ENGINEERING CHANGE NOTICE NO.

05110

DWG NO. 647.7700

DWG TITLE: STRUT ASSY

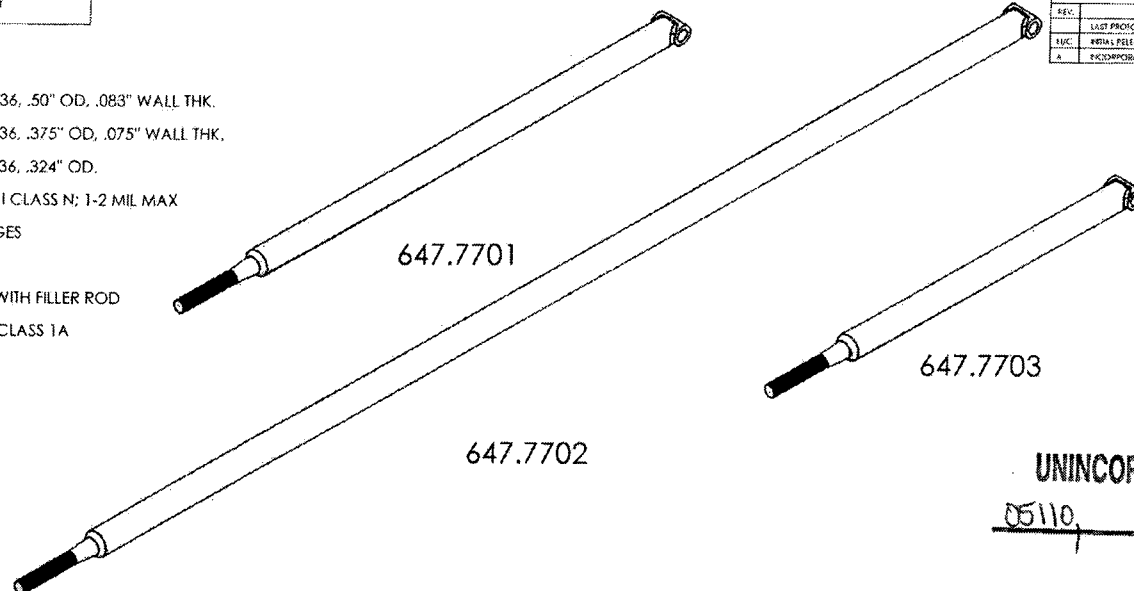
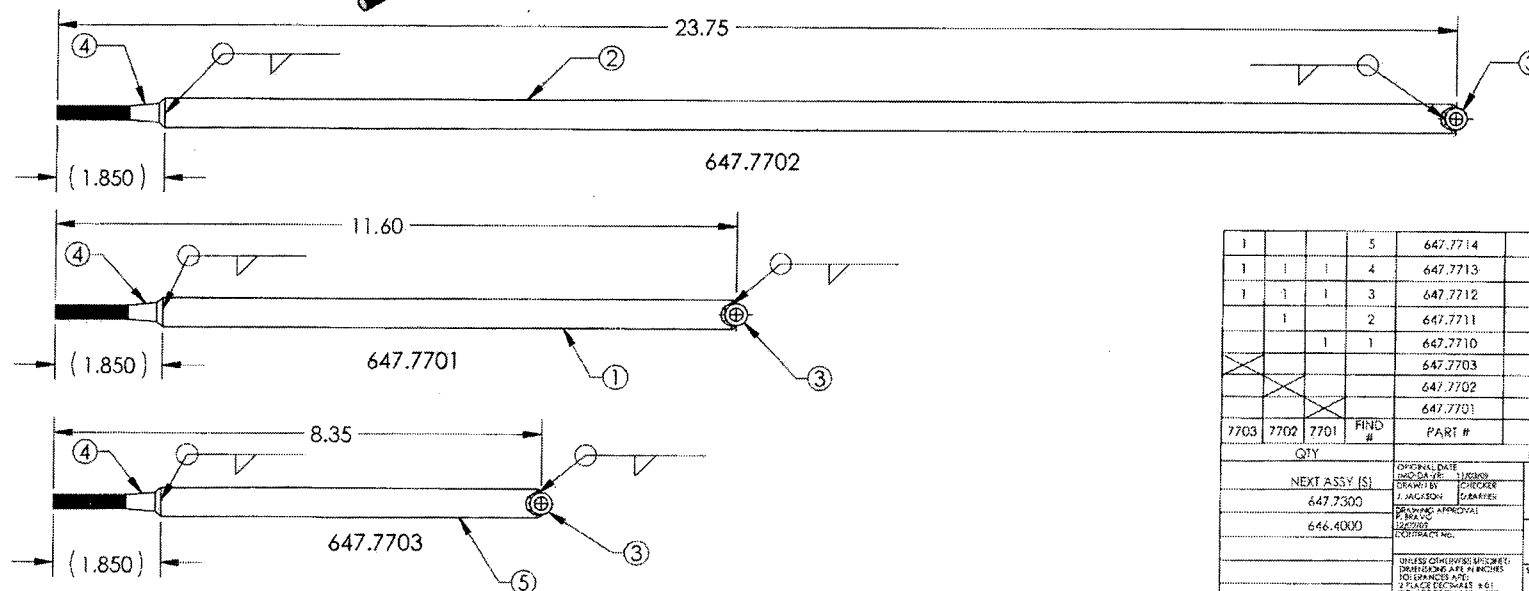
REASON: REVISED FINISH CALLOUT AS PER ECR 15-209

SHEET 1, NOTES IS:

- 1 MATERIAL: 4130 STEEL PER AMS-T-6736, .50" OD, .083" WALL THK.
- 2 MATERIAL: 4130 STEEL PER AMS-T-6736, .375" OD, .075" WALL THK.
- 3 MATERIAL: 4130 STEEL PER AMS-T-6736, .324" OD.
- 4 FINISH: PRIME IAW MIL-P-2337J TYPE I CLASS N; 1-2 MIL MAX
5. DEBURR AND BREAK ALL SHARP EDGES
6. IDENTIFY IAW MPP-120.
- 7 WELD IAW MIL-STD-2219. TIG WELD WITH FILLER ROD
- 8 FINISH: CAD PLATE IAW QQ-P-416F CLASS I TYPE II
- 9 MASK THREAD PRIOR TO FINISH
